APPLICATION NO.	FILING DATE	FIRST NAMED INVENTOR	ATTORNEY DOCKET NO.	CONFIRMATION NO.
10/502,015	07/20/2004	Hiroo Matsunaga	Q82646	8516
23373 7590 02/06/2007 SUGHRUE MION, PLLC 2100 PENNSYLVANIA AVENUE, N.W. SUITE 800 WASHINGTON, DC 20037			EXAMINER MAKI, STEVEN D	
			ART UNIT 1733	PAPER NUMBER
			MAIL DATE 02/06/2007	DELIVERY MODE PAPER

<p align="center">Advisory Action Before the Filing of an Appeal Brief</p>	Application No. 10/502,015	Applicant(s) MATSUNAGA, HIROO	
	Examiner Steven D. Maki	Art Unit 1733

FIG. 1

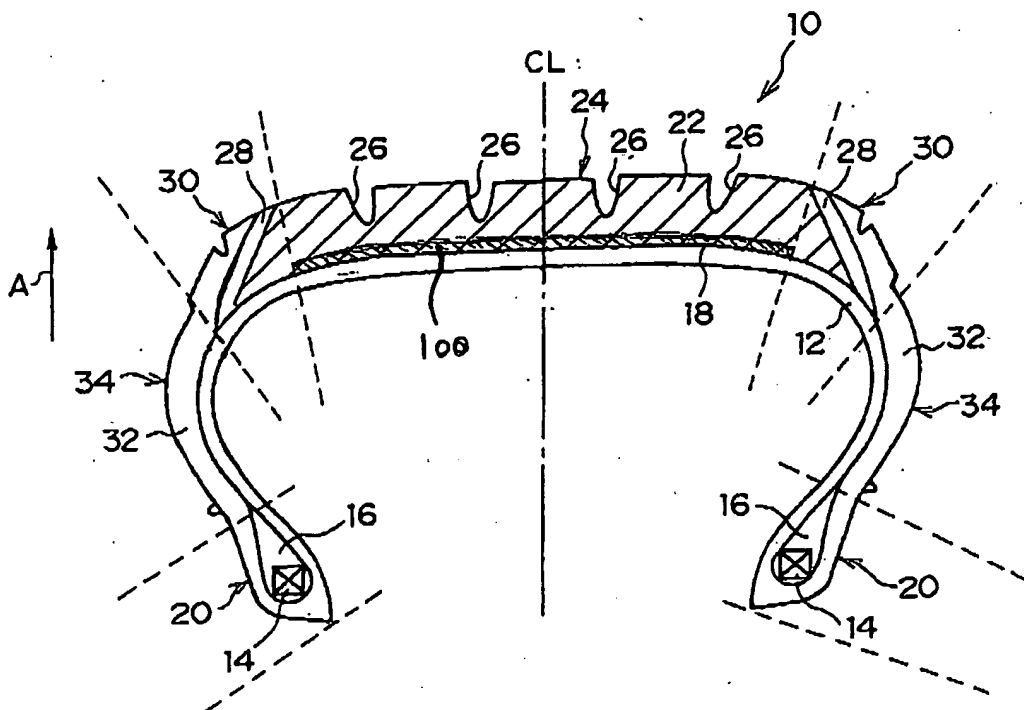
(1) in the drawings, adding illustration of "belt 100" to Figure 1 and in paragraph 5 on page 15 of the specification, changing "belt (not shown)" to --belt (see Fig. 1 - element 100)--;

(1) in the drawings, adding illustration of "belt 100" to Figure 1 and in paragraph 5 on page 15 of the specification, changing "belt (not shown)" to --belt (see Fig. 1 - element 100)--;

DO NOT ENTER
Jm 2-1-07
